Service Bulletin

TAT SB08-01

Issued: February 8, 2008
Model SR22 w/ Tornado Alley
Turbo, Inc. Turbonormalizer
installed pursuant to Engine
Technologies, Inc. STC
SA10588SC on Cirrus Design
Corporation Model SR 22 aircraft

Figure 1. Right side shown.
Left Side Similar.

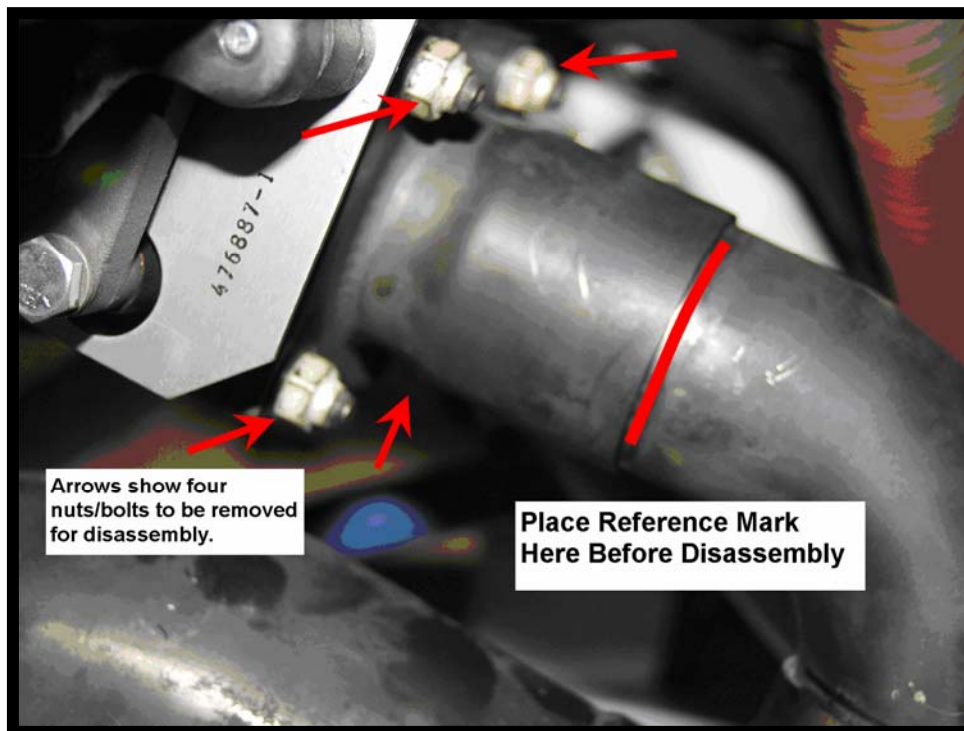
This Service Bulletin contains procedures to modify the right hand exhaust elbow (Group A) and both the right hand and the left hand exhaust elbow (Group B). This exhaust elbow is inserted between the tailpipe and the wastegate outlet fitting. See Figures 1 & 2.

- b. Visually locate the wastegate outlet on the aft side of the right hand wastegate. See Figure 1. Disconnect the heater hose clamp and hose from the intercooler to facilitate inspection and access.

- c. Visually inspect the right angle exhaust elbow and the area where the elbow inserts into the tailpipe, for any signs of a crack in the weld of the vertical receptacle in the tailpipe into which the short leg of the right angle elbow is inserted. If any cracks are observed, then contact Tornado Alley Turbo, Inc. for replacement parts before return to service or further flight.

- i. Measure the length of the elbow from the previously applied reference mark to the end of the long leg of the elbow.
 - j. If this measurement is greater than 1.00”, shorten the elbow so that the engagement, when re-installed, will be no more than 1.10” and not less than 1.00” as measured from the reference mark.

- k. If the engagement length is less than 1.00” but is more than 0.90” then simply re-install the elbow. If the engagement is less than 0.90” then contact Tornado Alley Turbo, Inc., for a replacement elbow.

Figure 2.
Left side.
Showing where to
place reference
mark before
disassembly.

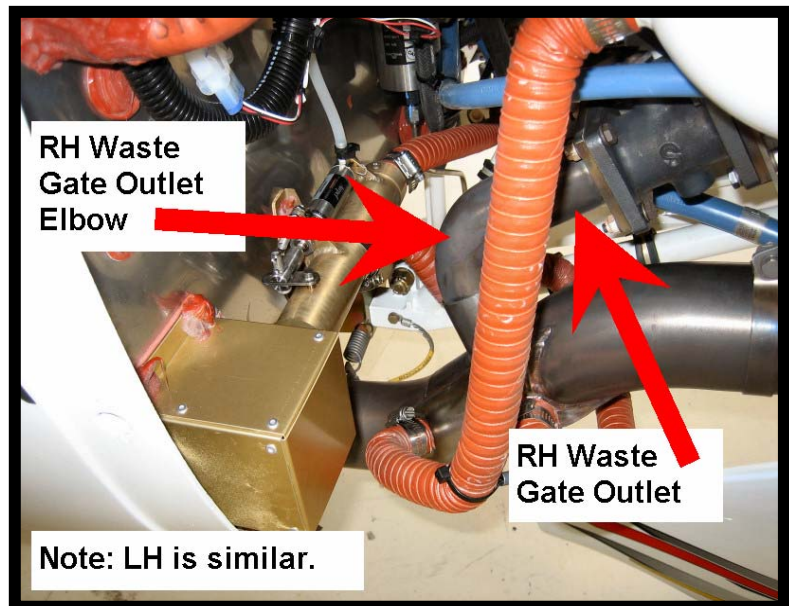
- d. Clean the area where the elbow is inserted into the wastegate outlet tube.
 - e. Mark the exhaust elbow at the aft end of the wastegate outlet tube.

- h. Remove the exhaust elbow from the wastegate outlet swaged tube and clean any exhaust residue from the elbow and wastegate outlet tube assembly. **Be careful to preserve the previously applied reference mark.**
